UNITED STATES PATENT AND TRADEMARK OFFICE

APPLICATION NO.	FILING DATE	FIRST NAMED INVENTOR	ATTORNEY DOCKET NO.	CONFIRMATION NO.
10/674,225	09/29/2003	Dennis A. Kramer	60,130-1898; 03MRA0456	2509

Office Action Summary	Application No. 10/674,225	Applicant(s) KRAMER, DENNIS A.	
	Examiner Melanie Torres	Art Unit 3683

DETAILED ACTION

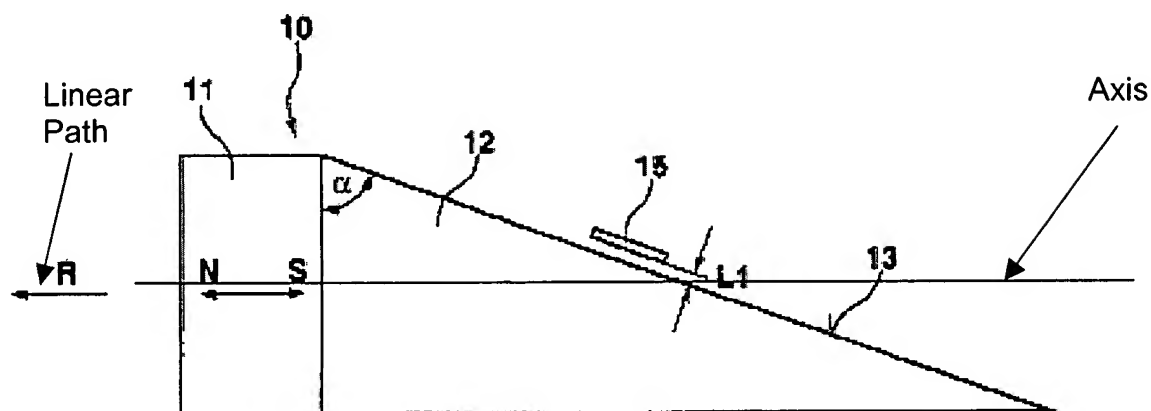
Re claims 13-17, Reichl et al. discloses a distance sensor comprising: a magnet (11) having at least a north pole and a south pole, with an axis defined extending through said north and said south poles; and a Hall effect sensor (15) said Hall effect sensor and said magnet being mounted for movement relative to each other along a linear path (R) said linear path being non-parallel to said axis. See below.
